**To:** Auburn Planning Board  
**From:** Megan Norwood, City Planner II  
**Re:** 204 Broad Street (PID 290-011), Two Proposed Apartment Buildings for a total of 18-units, amending Previously Approved 24-Unit Condominium Project from 1988 in the Multifamily Urban Zoning District.  
**Date:** December 10, 2019

**Measuring Building Height**  
(figure 1)

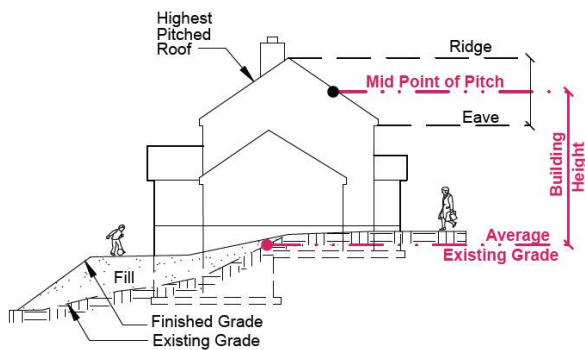
**Sec. 60-335(4) Height:** The building height in the MFU Zone is restricted to two and a half stories or 35 feet, the exceptions being a church, temple or windmill. The proposed building height is 35 feet, the

application materials will be updated to reflect this height. Staff has used the “mean of the gable” for building height measurements in the past. It is a common architectural standard that is not spelled out in the ordinance which allows some latitude with the need for steeper pitches for Maine winters and for matching local character.

- The building height shall be limited to 35 feet as measured to the mean of the gable (as discussed above).
- A lighting plan shall be provided before the issuance of a building permit;
- An addressing plan shall be provided to the Addressing Officer before the issuance of a building permit;
- Bonding and inspection fees must be approved and paid and a notice to proceed obtained from the City Engineer;
- The ADA parking spaces shall be adjusted to include spaces in front of the 6-unit apartment building as well;
